**RE: Lot 20 Block 5 Volcano Cliffs Unit 18 SAD 228
6616 Sujeto Rd. NW
Grading and Drainage Plan
Rev. Engineers Stamp Date; 3/3/2022 (D10D003K20)**

ENGINEER'S SEAL	LOT 20 BLK 5 UN 18 VOCANO CLIFFS 6616 SUJETO ROAD, N.W. POOL ADDITION GRADING AND DRAINAGE PLAN  <i>Rio Grande Engineering</i> PO BOX 83604 ALBUQUERQUE, NM 87199 (505) 321-9099	DRAWN BY DEM
 3/3/22		DATE 3-2-22
		Lot 20 Blk 5 Un 18 VC.DWG
		SHEET # C1
		JOB #

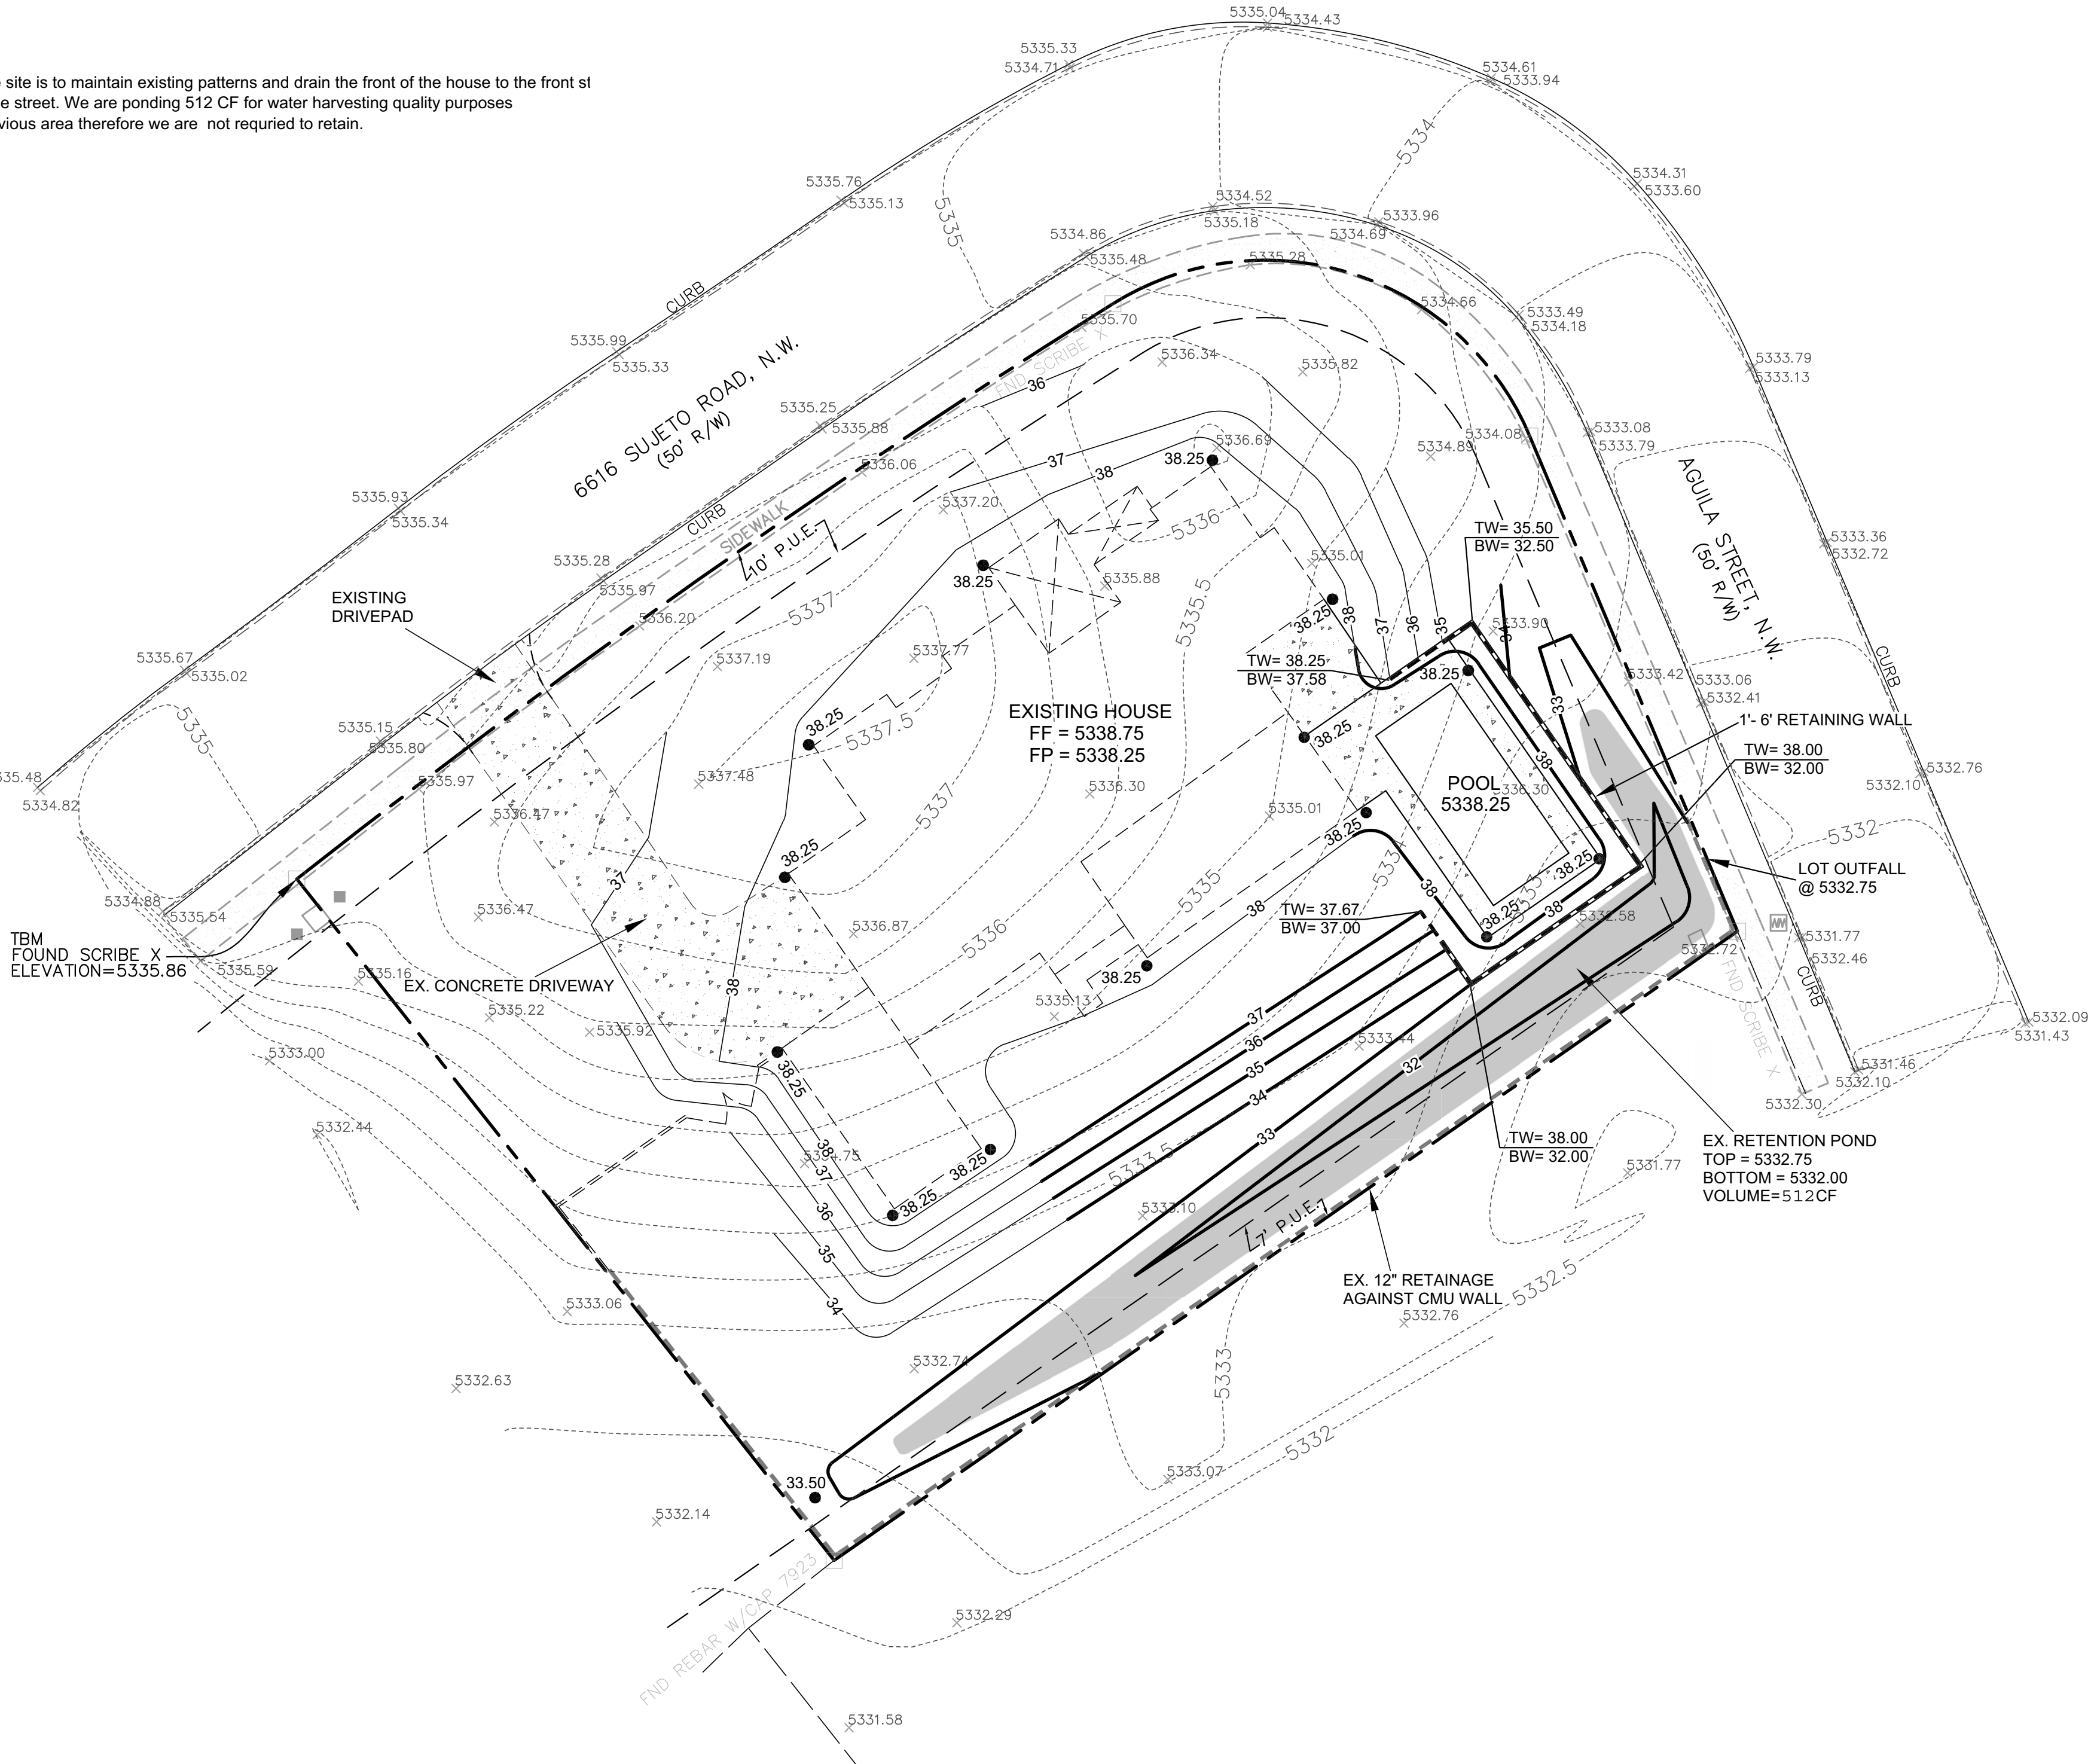
Based upon the information provided in your submittal received 3/23/2022, this plan is approved for a revised Grading Permit. **Dirt is not allowed to climb the curb, use crusher fines or lumber for this purpose.**
